WATER QUALITY MEMORANDUM

Utah Coal Regulatory Program

December 26, 2012

RE: 2012 Second Quarter Water Monitoring, PacifiCorp, Deer Creek Mine.
C/015/0018, Task ID #4116

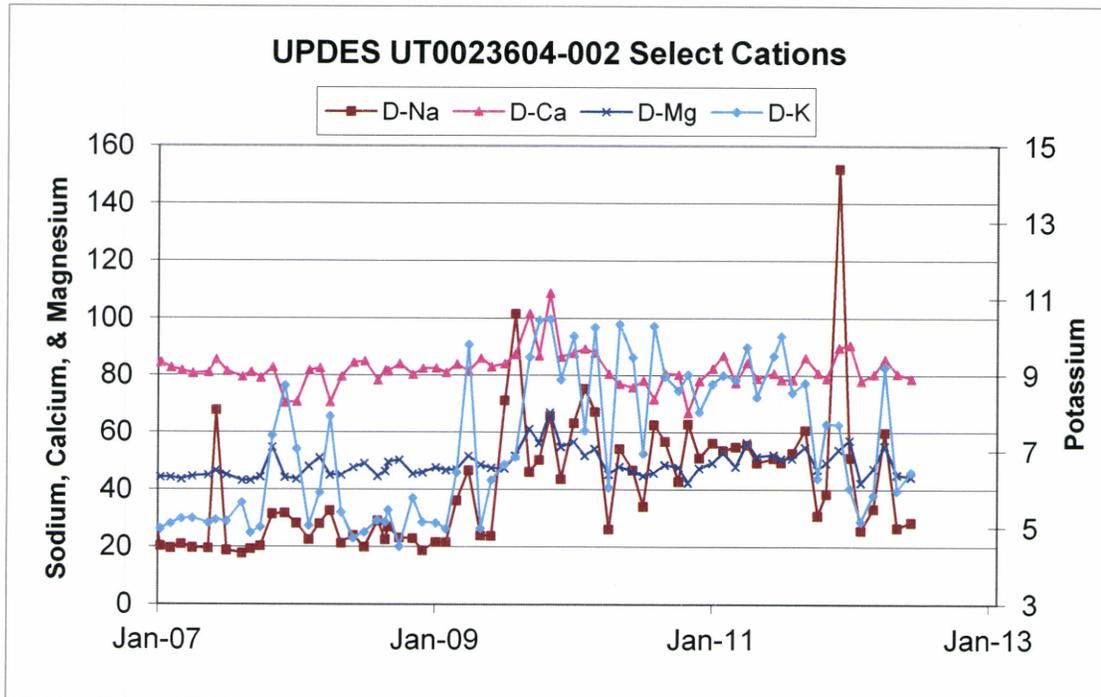
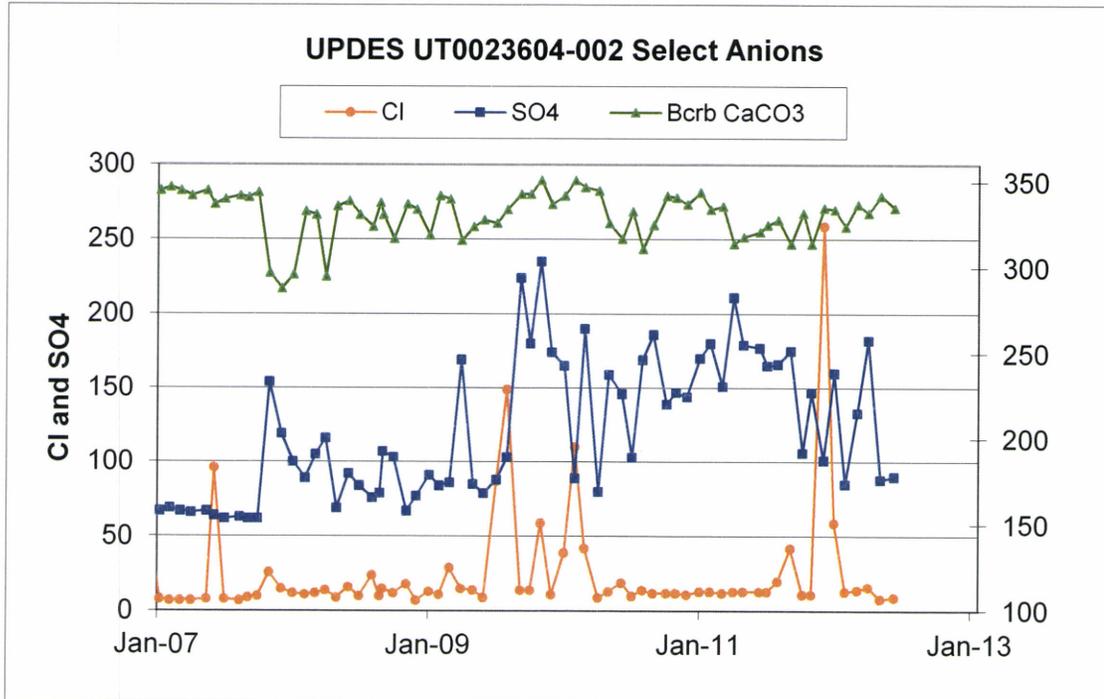
Recently, potassium values have frequently been outside two standard deviations from the mean at UT0023604-002, but – as can be seen on the following charts – with the exception of bicarbonate, major ion concentrations have tended to fluctuated upwards in recent years

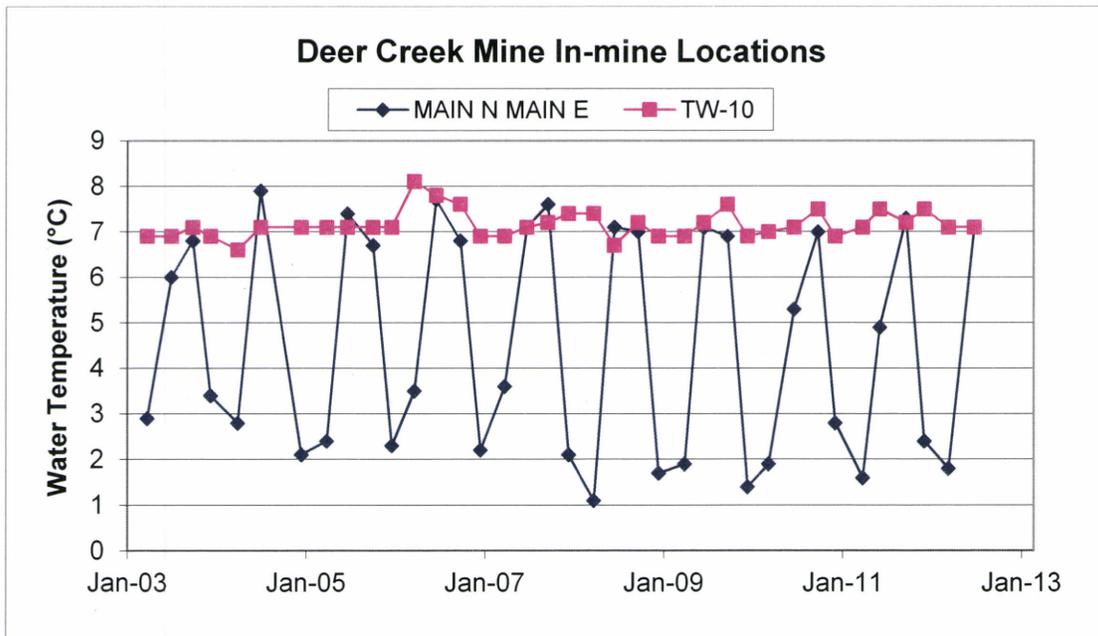
The water temperature at Main North Main East varies seasonally year-after-year (see following chart), indicating that this in-mine source is most likely fed by infiltration of surface water rather than draining surrounding strata. The temperature at TW-10 shows some seasonal variation but it is not as definitive as at Main North Main East.

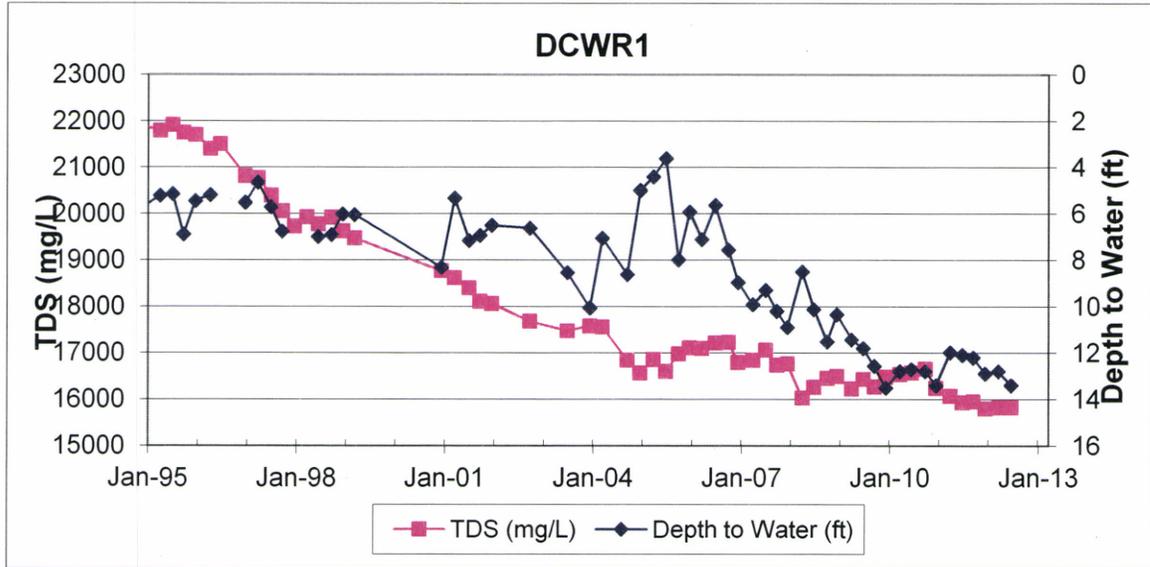
Although it hasn't been flagged as varying from the mean by more than two standard deviations, water level at DCWR1 has been dropping since 2006 (following a small rise in 2004-2005). TDS was dropping at a similar rate, but now appears to have stabilized. These changes are probably from factors other than disposal of waste rock at this site: a similar drop in water level is seen at WCWR1 at the Cottonwood/Wilberg Mine Waste Rock Disposal Site.

TDS/field electric conductivity ratios – all sites

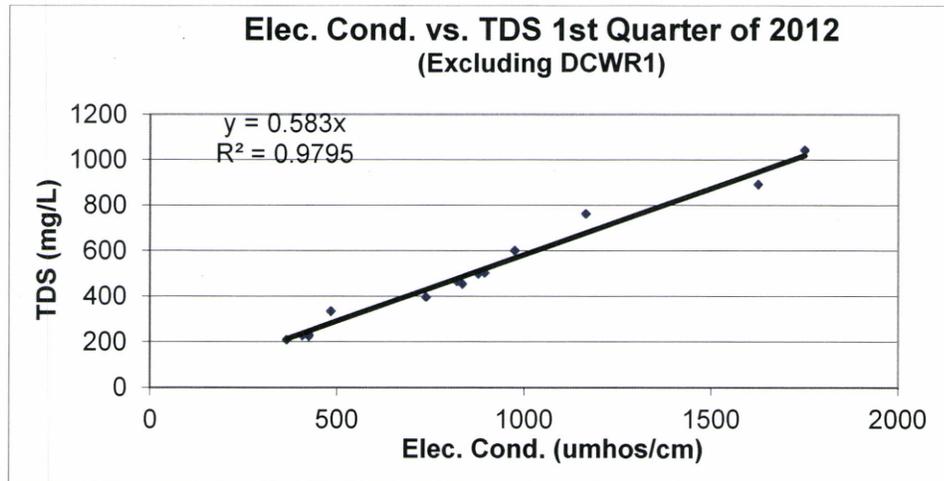
The TDS/field electric conductivity ratio typically falls between 0.52 and 0.76 for dissolved solids concentrations found in natural waters. As the following chart shows, data for these two parameters submitted for the Second Quarter 2012 at the Deer Creek Mine generally result in a ratio that falls within this range: DCWR1 is not included in the trendline calculation.
